2. Recommendation to continue the public hearing for the 310 Georgia Design Review and Townhouse Preliminary Plat applications to the April 15, 2026 Planning and Zoning Commission Meeting.
3. Recommendation to review and provide feedback on the Preapplication Design Review for the proposed multi-family development at 680 N Leadville Avenue.

STAFF REPORT
KETCHUM PLANNING AND ZONING COMMISSION
REGULAR MEETING OF MARCH 18, 2026

REVIEWER: Abby Rivin - Senior Planner

Figure 5: Building Section (Sheet A3.1)

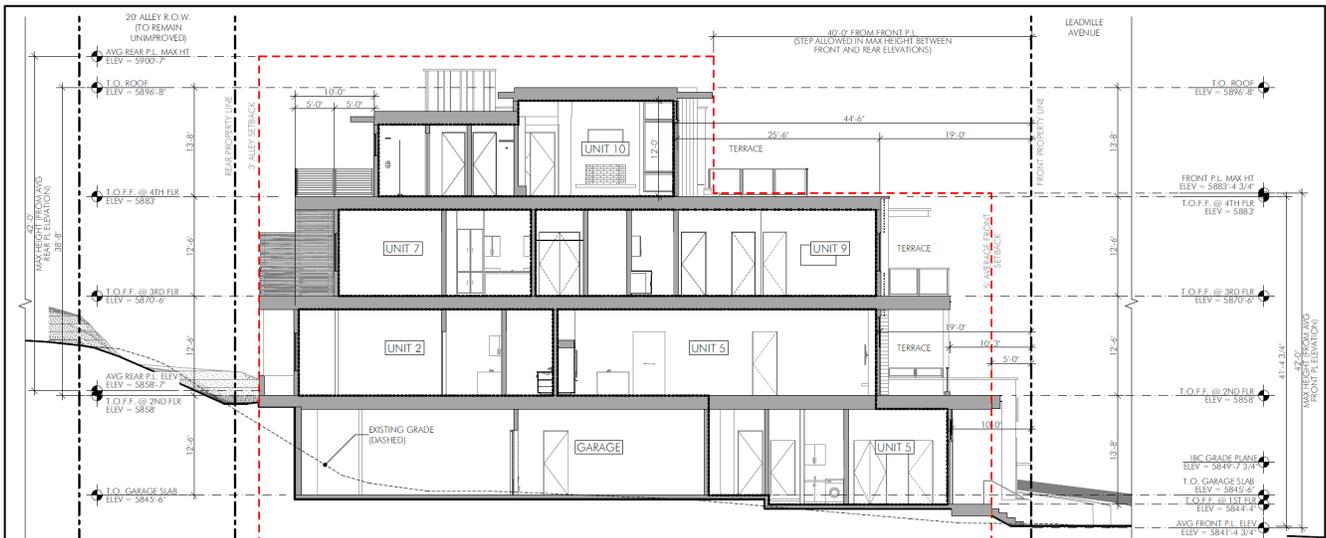
The building height calculation follows the methodology defined KMC §17.08.020. This methodology allows side facades to be stepped up or down to transition from the highest elevation of the front façade height to the highest elevation of the rear façade but requires that no step occur within 40 feet of the front property line or within 35 feet of the rear property line.

As shown in the building section on sheet A3.1 of the projects plans (see Attachment A and Figure 5), the side façade steps up to transition to the higher rear façade elevation. This step up to the fourth floor occurs 44.5 feet from the front property line, consistent with zoning code requirements.

FIRST FLOOR PLAN
SCALE: 1/8" = 1'-0"

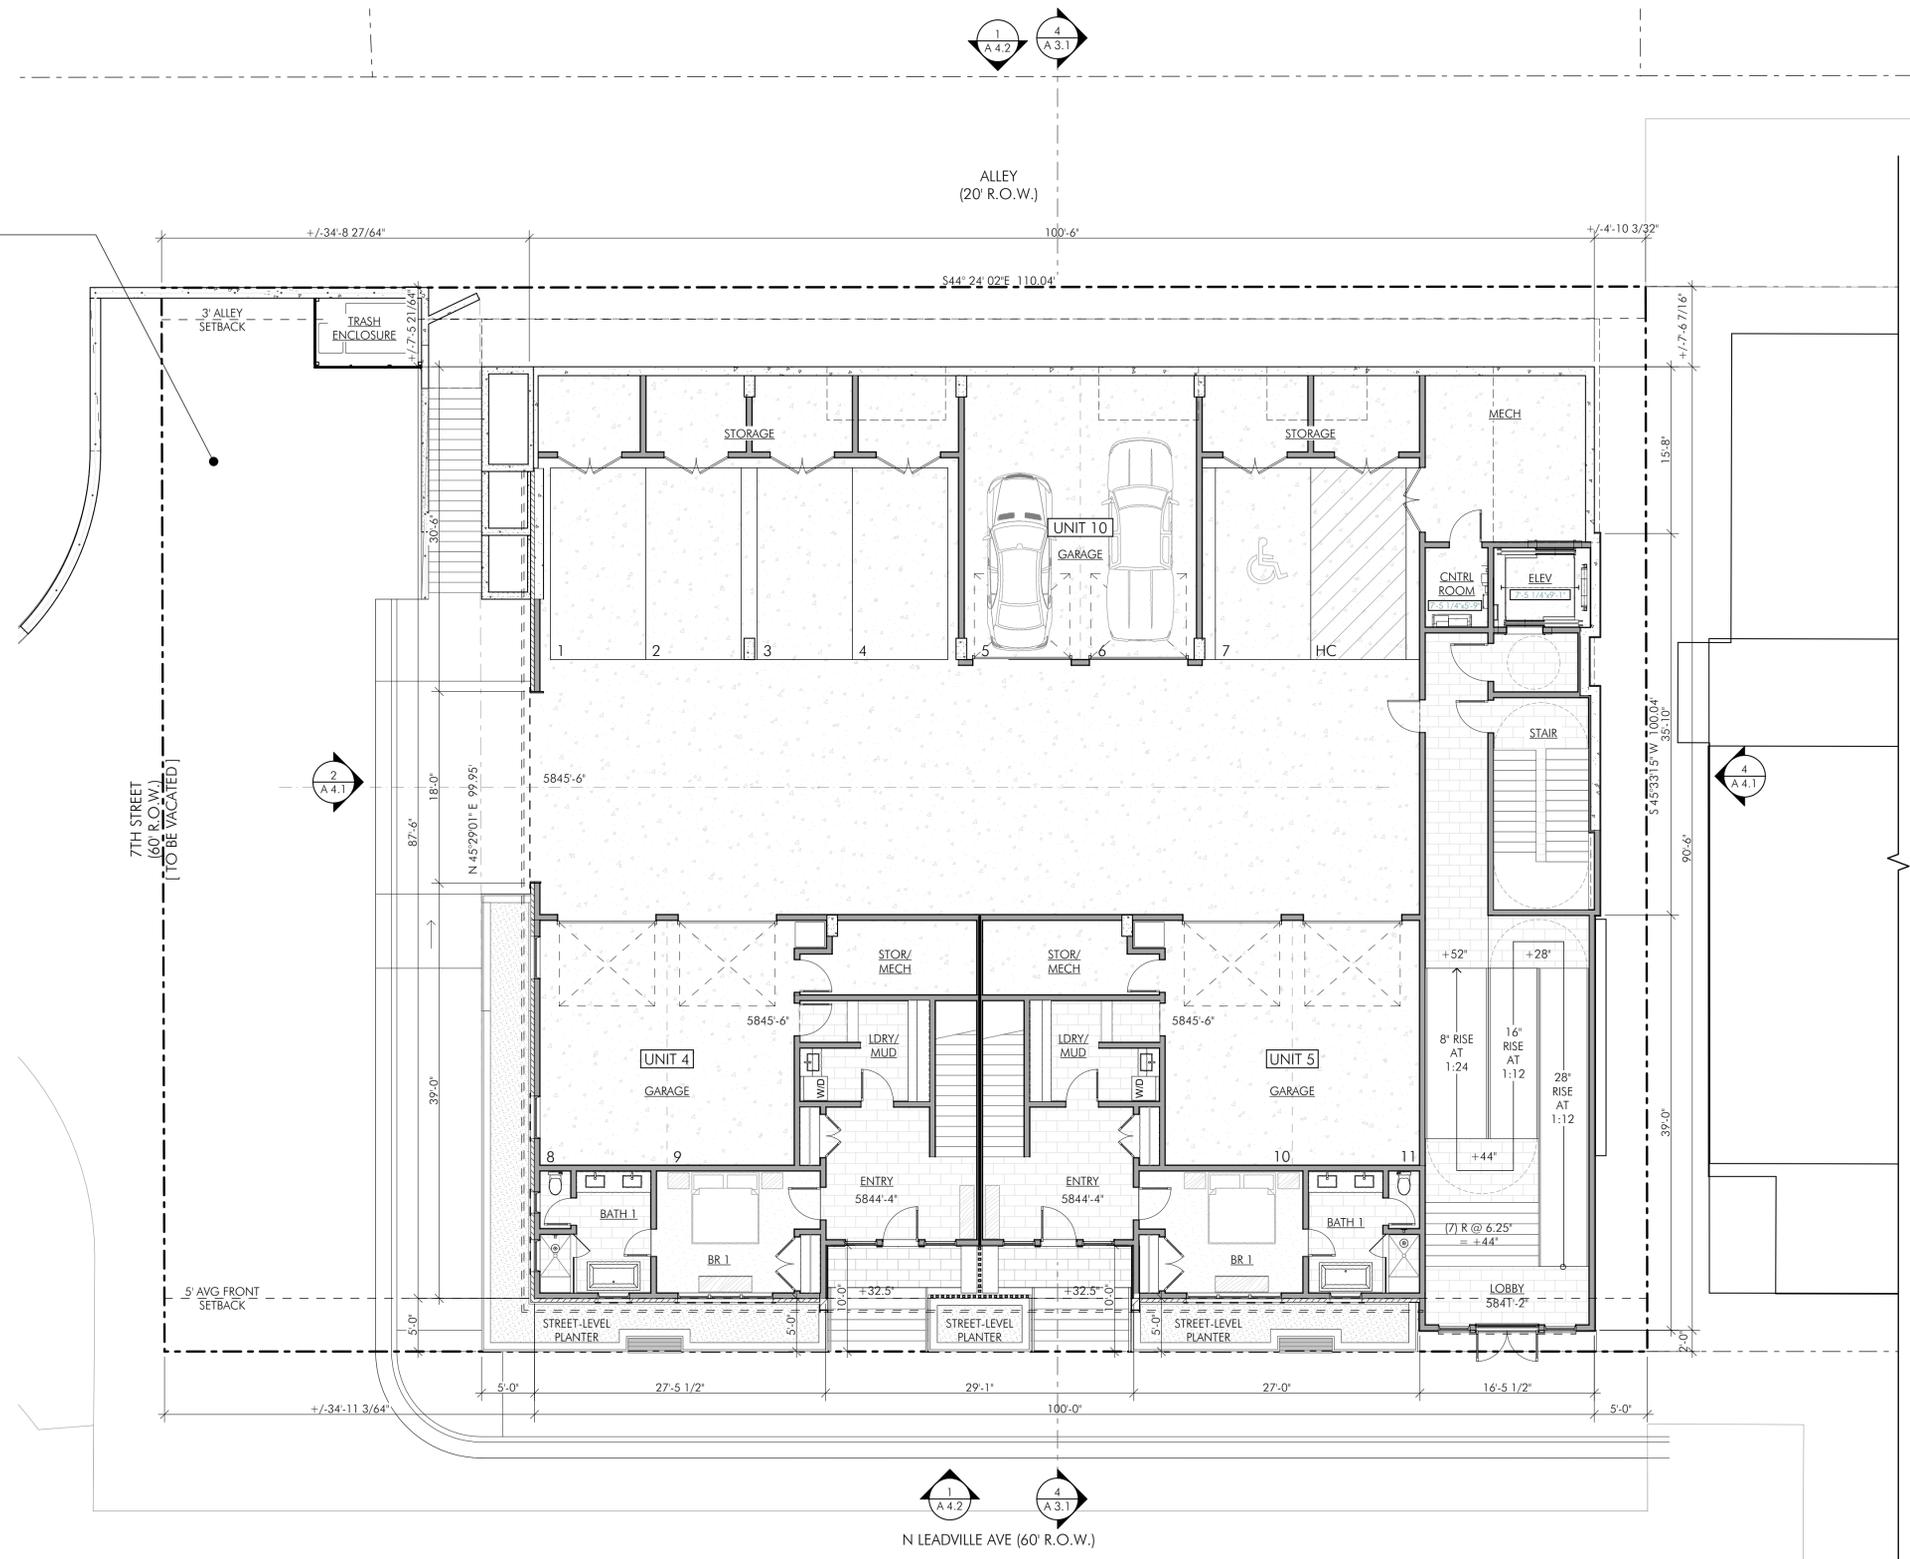
As shown in Figure 6, the project proposes a 11-foot-tall retaining wall along the potential vacated portion of the 7th Street ROW. KMC §17.124.130.A limits walls to six feet in height, and KMC §17.124.130.E2 requires all retaining structures, including footings or foundations, be setback at least one foot from any property or ROW line. KMC §17.124.130.E3 authorizes the Administrator, in consultation with the Public Works Director, to waive or reduce the required wall separation distance and increase the maximum height of a retaining structure if the applicant demonstrates that the reduced separation and increased height are either:

8. *Parking Stall & Aisle Width Dimensions*—The first-floor plan on Sheet A2.1 shows 11 off-street parking spaces; however, the dimensions of the stalls and drive aisle are not provided. Pursuant to KMC §17.125.030.A, 90-degree parking spaces must be 9 feet wide by 18 feet long, with a 24-foot-wide drive aisle. Please specify the parking stall and aisle dimensions on the project plans submitted with the final Design Review application.

9. *ADA Parking Space*—Pursuant to KMC §17.125.030.A, ADA parking spaces must meet the dimensional requirements outlined in the current ADA Standards for Accessible Design. The parking garage plan on Sheet A2.1 does not show a designated ADA space. Please designate an ADA parking space and provide dimensions that comply with the current ADA standards.

ROOF PLAN
 SCALE: 1/8" = 1'-0"

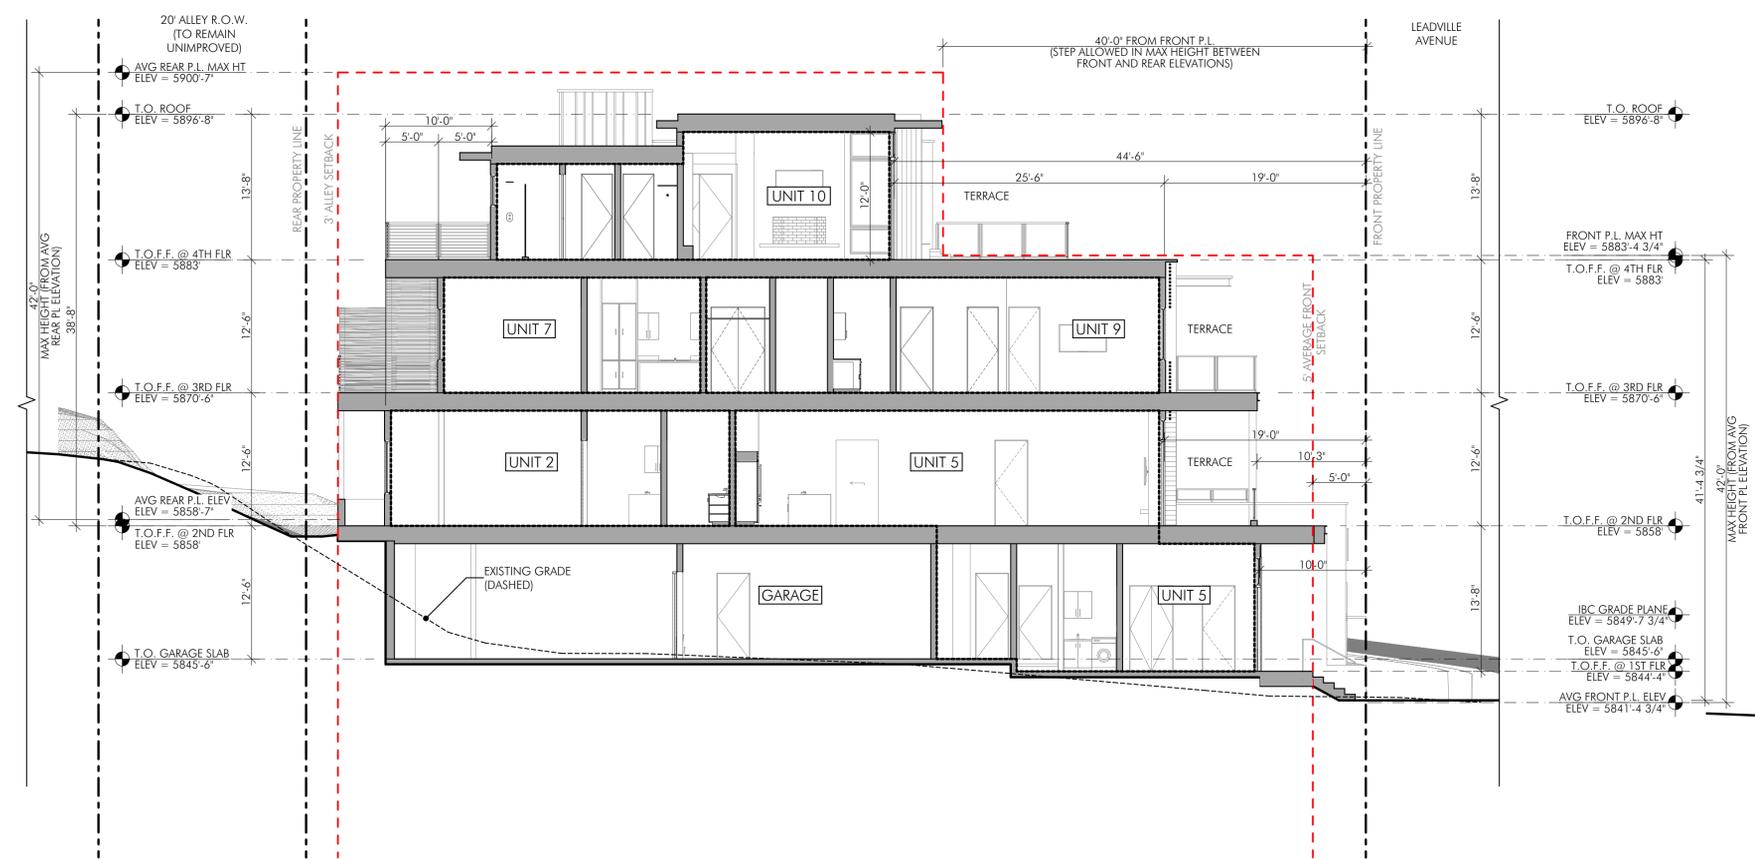
The proposed multi-family development does not include a roof deck. The roof plan on Sheet A2.5 does not indicate any rooftop mechanical equipment. If rooftop mechanical or electrical equipment is proposed, the location and size must be shown on the roof plan submitted with the Final Design Review application.

7. *Rooftop Mechanical Equipment*—The roof plan on Sheet A2.5 does not indicate any rooftop mechanical equipment. Any proposed equipment must be shown on the roof plan. Per KMC §17.12.040, mechanical equipment and solar panels may extend up to 5 feet above the roof surface and must be set back at least 10 feet from all building facades. In addition, roof- and ground-mounted mechanical and electrical equipment must be fully screened from public view with screening compatible with the building design (KMC §17.96.070.C2).
